Memorandum

Date: May 28, 2008
To: Mark Grey, Building Industry Association of Southern California
From: Lisa Austin, Felicia Federico, Aaron Poresky, and Eric Strecker,
Geosyntec Consultants
Subject: Review of Investigation of the Feasibility and Benefits of Low-Impact
Site Design Practices ("LID") for Ventura County
Geosyntec Project: LA0157

ATTACHMENT 2

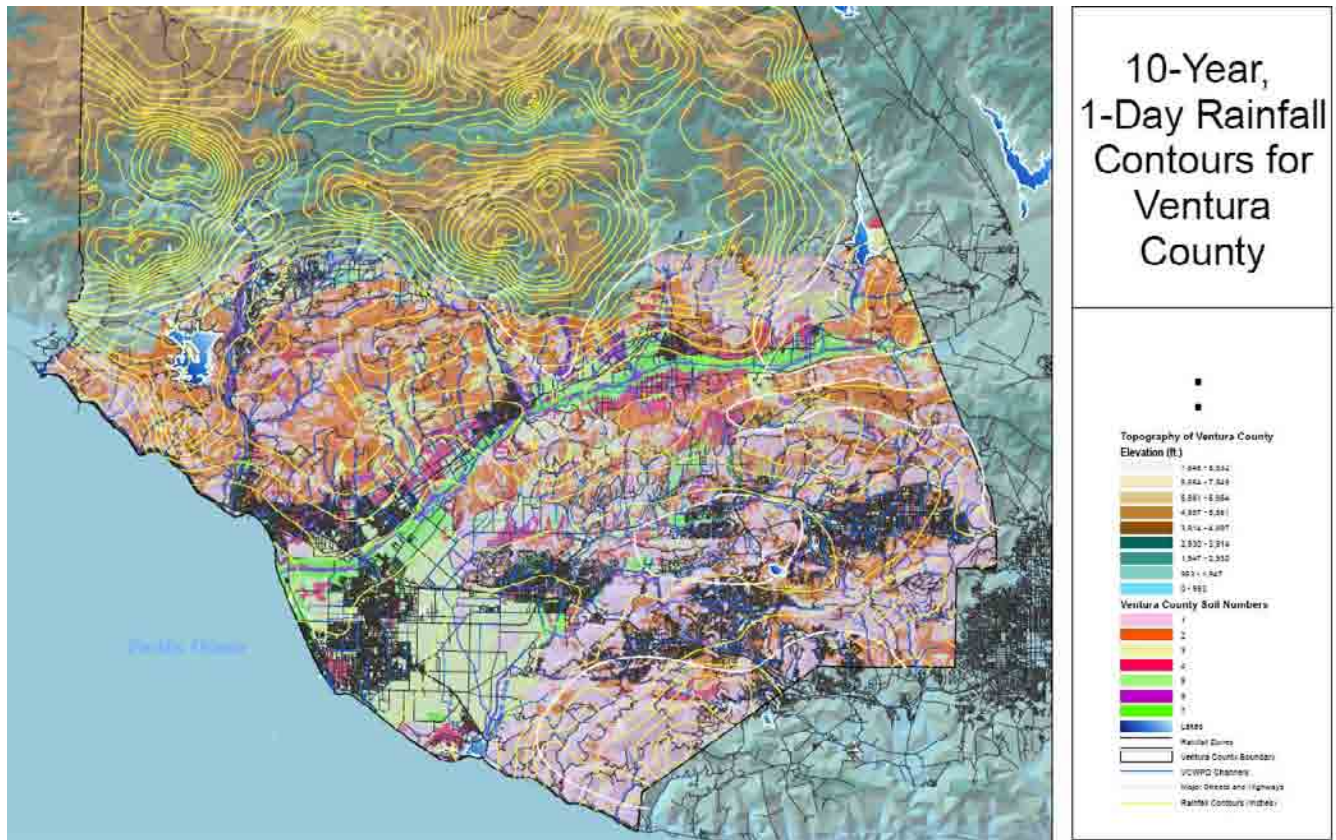
A map that illustrates Ventura County soil types is provided in Attachment 2. Soils have been grouped by the County into seven classifications ranging from a very low infiltration rate (Soil Type 1) to a very high infiltration rate (Soil Type 7). The map in Attachment 2 shows that the soils in the coastal portion of the County (City of Ventura and Oxnard) are predominately Type 3 soils, which have a relatively slow infiltration rate (0.5 inches per hour) when thoroughly wetted, are chiefly soils that have a layer impeding downward movement of water, or are moderately fine textured soils that have a slow infiltration rate when dry. The eastern portion of the County (Thousand Oaks, Simi Valley, and Moorpark) appear to have predominately Type 1 soils, which are soils with a very low infiltration rate (0.25 inches per hour) when wetted. They are chiefly clays that have a high shrink-swell potential, soils that have a high permanent water table, soils that have a claypan clay layer at or near the surface, or soils that are shallow over nearly impervious material. Type 1 soils will have very, very low infiltration rates when compacted. By comparison, the Chralowicz study analyzed scenarios with infiltration rates between 0.5 and 2.0 inches per hour.
